Site Plan Review
Staff Report – March 21, 2019

RE: Proposed Car Wash
Tax Map Parcel No. 148-A-46B, 46D
4176 and 4196 S Amherst Hwy
Site Plan for Car Wash in the B-2 General Commercial District

**RE: Site Plan #2019-037 for Car Wash in the B-2 General Commercial District;
4176 and 4196 S. Amherst Hwy;
Tax Map Parcel # 148-A-46B, 46D**

**RE: W4 Development Carwash
Site Plan Review**

W4	DEVELOPMENT
SHEET TITLE	EXISTING CONDITIONS & DEMO PLAN
SHEET NUMBER	2
PROJECT NUMBER	18001W4D
DATE	03/08/19

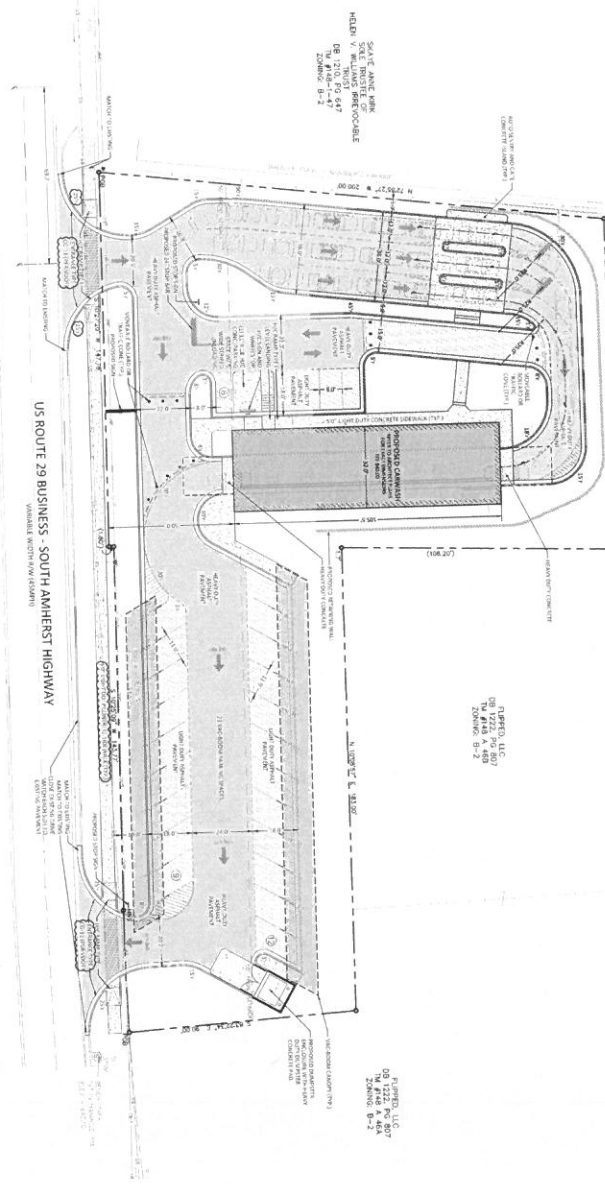
1. Per Section 1104.02.4.b, show the current zoning of the adjoining owners on the map of existing conditions (Sheet 2).
2. Per Section 1104.02.5.a, include on the cover sheet signature blocks for the zoning administrator, Virginia Department of Transportation, Amherst County Service Authority, and Erosion and Sediment Control Administrator.
3. Per Section 1104.03.3.e, proposed location, size, and design of signs can be included on the plan set.
4. Per Section 1104.03.3.j, indicate proposed location, direction of, power, time and use of outdoor lighting.
5. Per Section 1104.03.3.m, include the construction of a sidewalk in the plans (Section 606).

3. Sht. 2: An existing water meter is shown, with no indication of the service lines to and from it and no indication as to its intended use. Is it to be removed or remain in service?

4. Sht. 2: The existing public sanitary sewer is continuous across the entire property frontage, but is not shown across the property with the two Rte 29 entrances. Are there no sewer manholes along this long stretch of sewer?

5. Sht. 2: The three existing signs (one in front of the 2 story building and two at the southern limits of the asphalt near Rte 29) appear to encroach into the public sewer easement along the site frontage and will need to be removed.
